NUVO - BACK TO BACK
STACKED TERRACE HOMES

LOWER UNIT

REVISION: JANUARY 17, 2023

PATHWAYS BUILDING 2 UNIT 110

FRIDGE / RANGE WALL ELEVATION

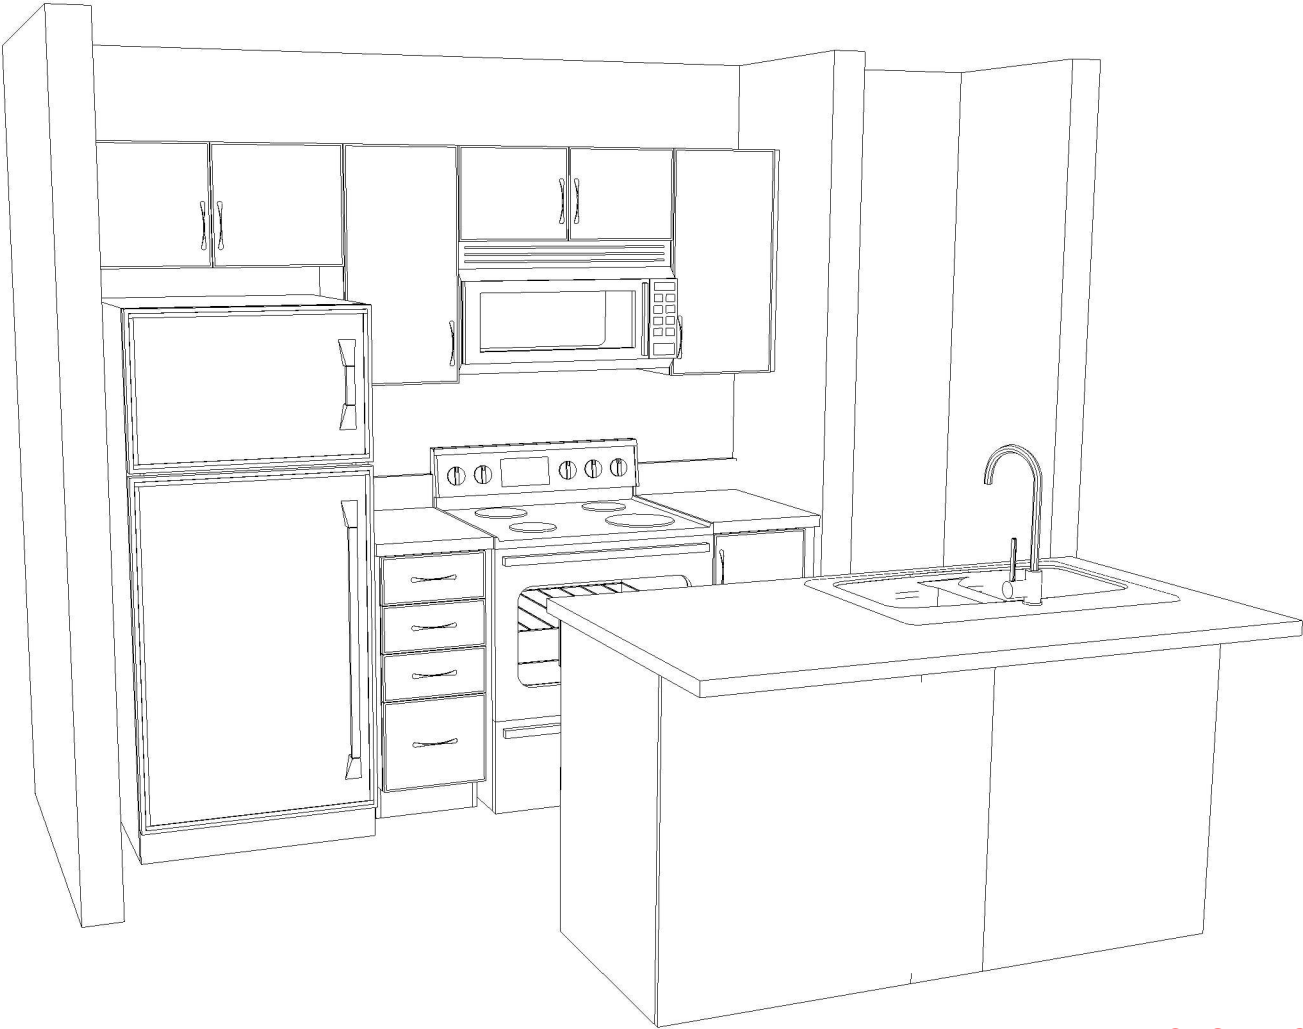
DELETE 4" BACKSPLASH

LOWER UNIT VANITIES - 3D VIEW

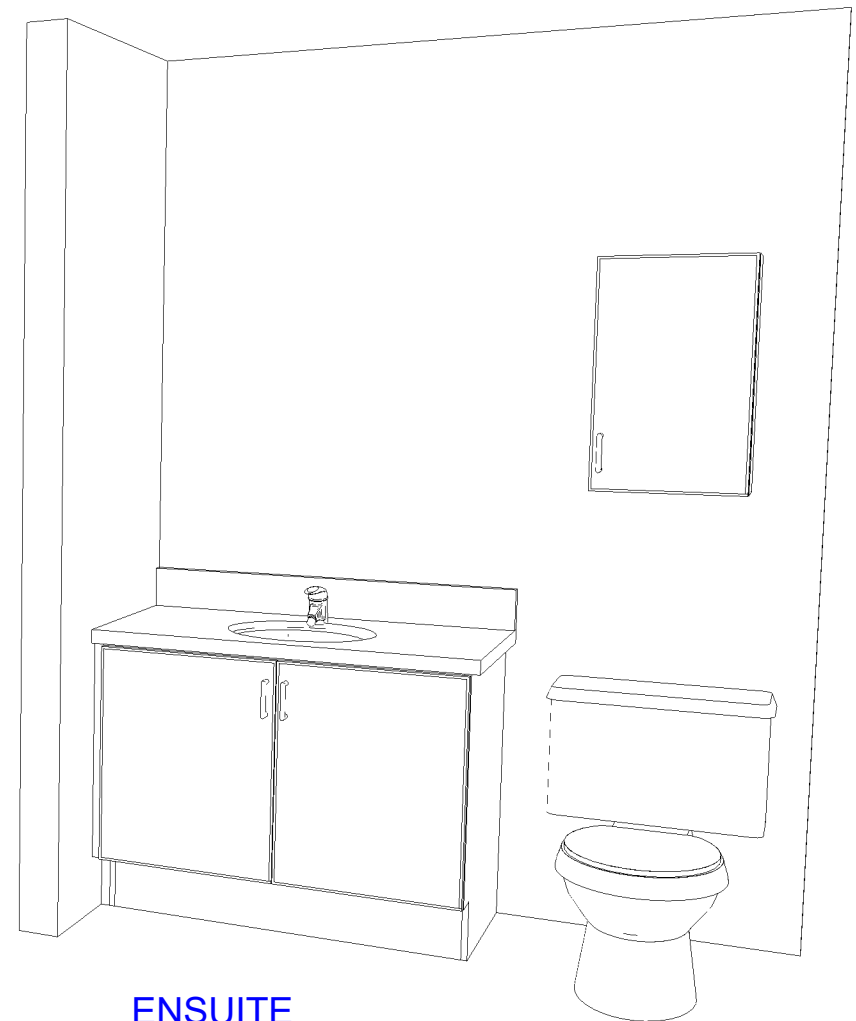
DELETE 4" BACKSPLASH IN ALL BATHROOMS
